File PP-1996-111

Name: The Knolls - 27 1/2 Road and Cortland Avenue - Preliminary Plan

Preliminary Plan - The Knolls
PP-96-111
Review Comments
Staff: Bill Nebeker

RESPONSE TO REVIEW COMMENTS

PHASING PLAN

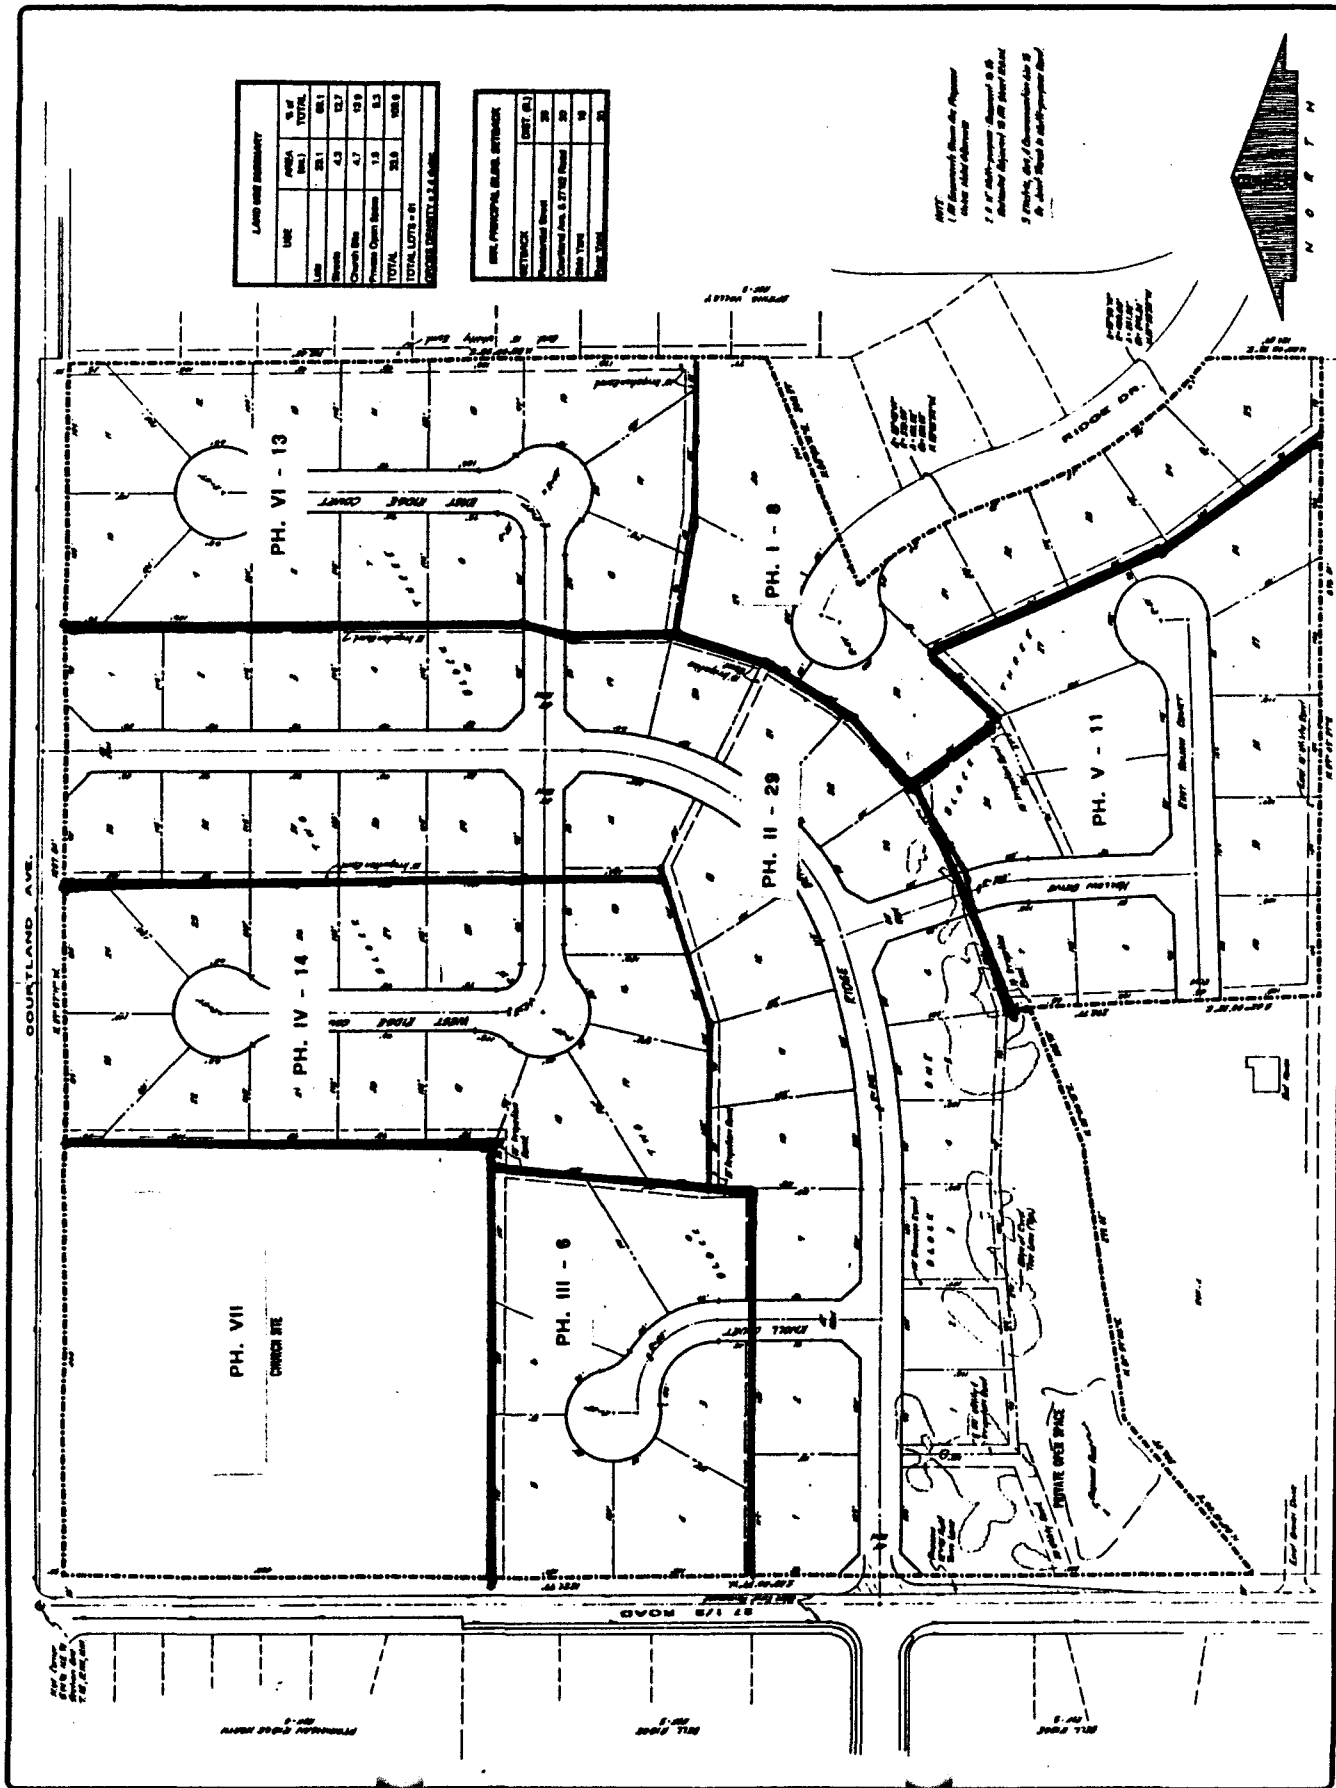
10. Common usable open space/recreation area is required.
11. A revised phasing plan must be submitted to reflect the above comments.
12. Since this subdivision is adjacent to and attaches with Spring Valley which has detached sidewalks, I strongly recommend that detached sidewalks be included in this subdivision. They require a little extra right-of-way but add so much to the aesthetics of the subdivision. (Compare the feeling of driving through Spring Valley (detached sidewalks) with Bell Ridge (attached sidewalks) subdivision to the west.)

DRAWN	T.M.
CHECKED	A.L.
DATE	JAN. 7, 78
SCALE	1"=50'
JOB NO.	
SHEET	
THREE	
OF 3	SHEETS

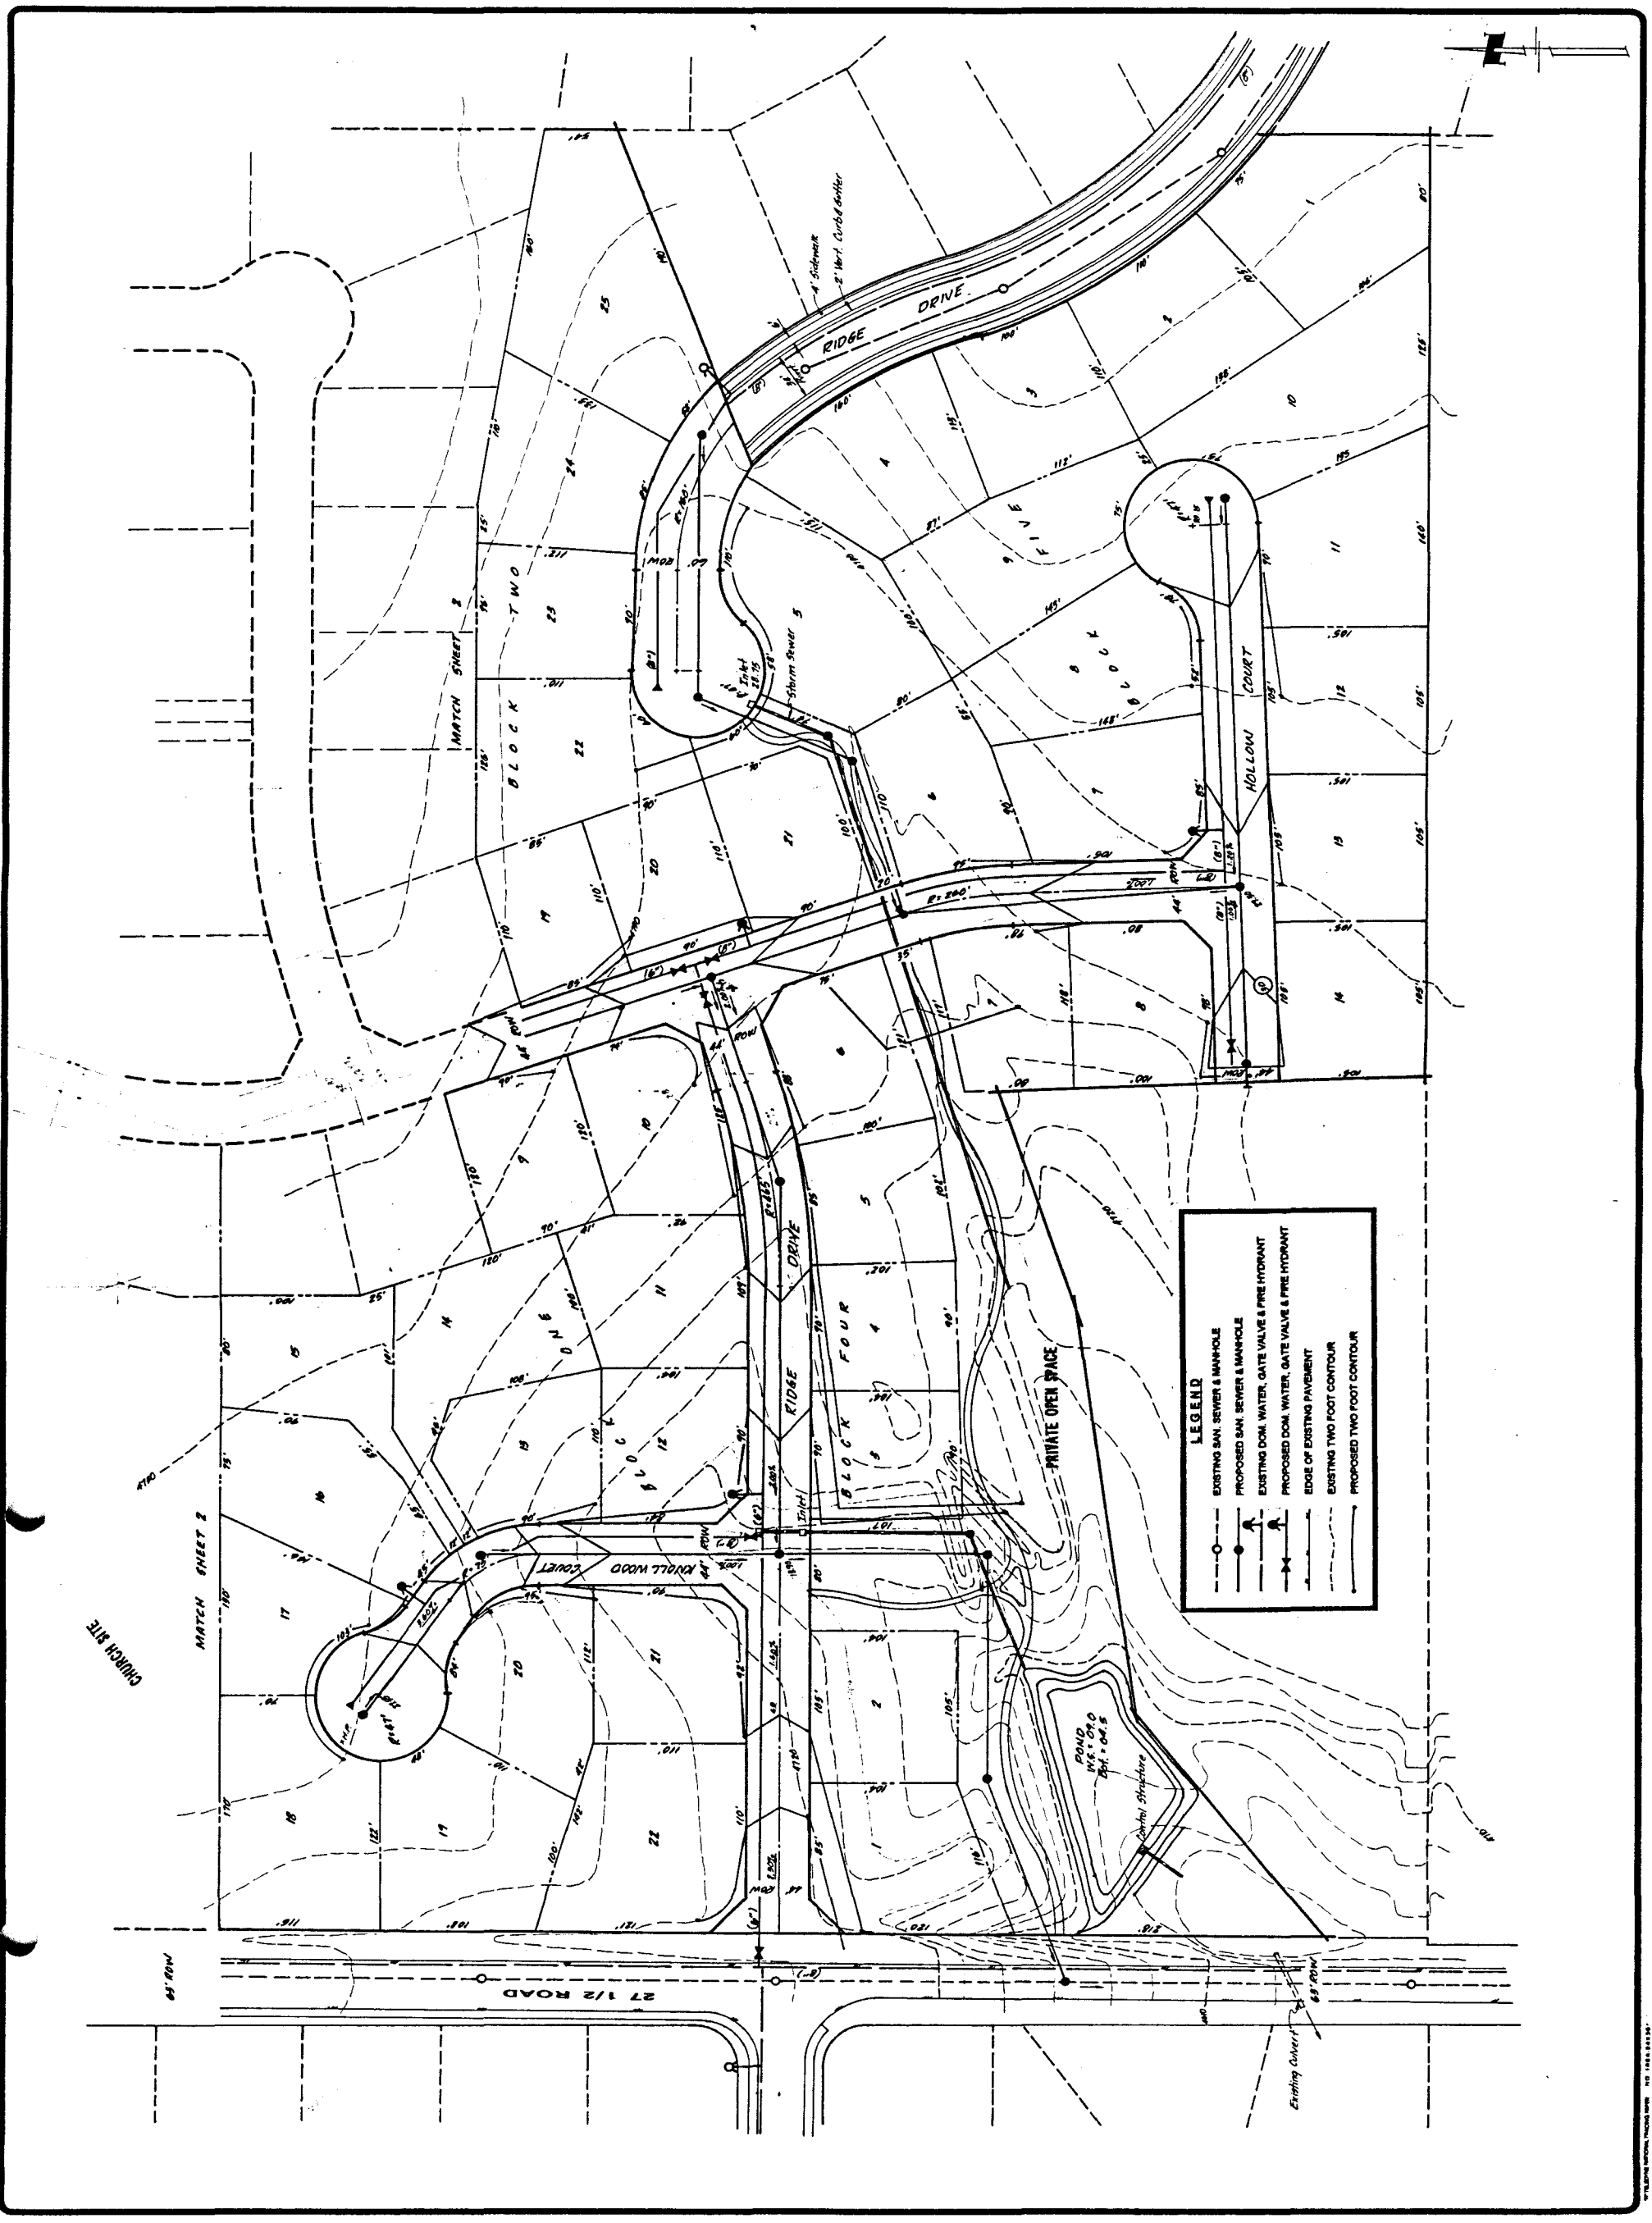
1. The Preliminary Plan does not meet some specifications in the SSID manual.
 - a. Scale must be 1" = 20', 30' 40' or 50' not 60'.
 - b. Relabel Preliminary Site Plan as Preliminary Plan

- c. Preliminary Plan is missing Title block with names, titles, preparation and revision dates.
 - d. Utility vendors to site not listed.
 - e. Existing lots not shown. Adjacent lots not shown to the north or south. South Piazza right-of-way not shown on plat.

- f. Existing drainage system in Cortland Avenue not shown.
2. A portion of this site is located in the Airport Critical Zone, which contrary to the general project report is not compatible, but requires a Special Use Permit (SUP) for residential densities less than 4 units per acre and for the church. A SUP will be required at the time of final plan approval and at the time of construction of the church. Please note that the church will not be allowed to have a school (other than typical religious Sunday School) because of the Airport Critical Zone. The Airport Critical Zone boundary shall be placed on the preliminary plan.

1. The plan has been redrawn to a scale of 1" = 50'.
2. The plan has been relabeled from "Preliminary Site Plan" to read Preliminary Plan.
3. The title block has been revised to include the developer's and preparer's name and address.
4. A directory of utility providers has been added to the plan.
5. All existing lots within 250 feet of the property boundary are now shown on the plan.
6. The Airport Critical Zone Boundary has been added to the plan.
7. The street names have been revised.
8. A pedestrian pathway has been added between Ridge Drive and the planned private open space.
9. The private open space has been reconfigured to allow for increased pedestrian access.
10. Even though the Church Site was included within the property as described in the initial submittal a lot and block number for the site has been added to the plan.
